# **Annex O**

## **Assessment of RP6 Network Investment Direct Allowances**

**Final Determination**

**30 June 2017**

**Figure 2.1: Undereaves delivery in RP5**

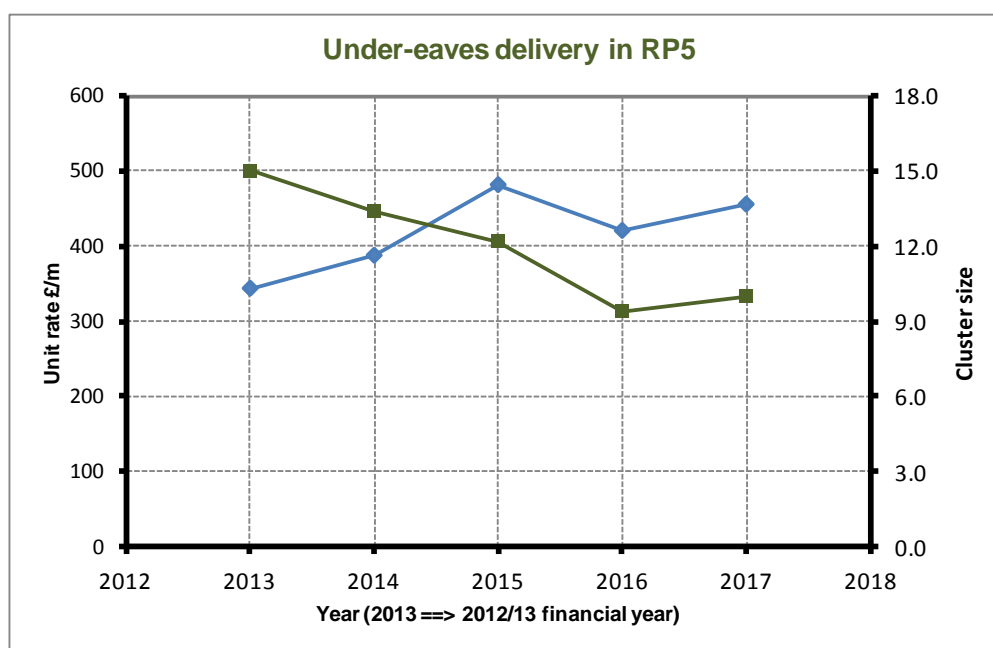
2.155 This information is reproduced in Figure 1 below which superimposes the movement in cluster size and annual unit rate for RP5.:

2.156 The basic premise of the company's argument is that there is a strong inverse correlation between the size of cluster and the unit cost of delivery and the cluster size will continue to fall in RP6. In respect of this argument, we note that:
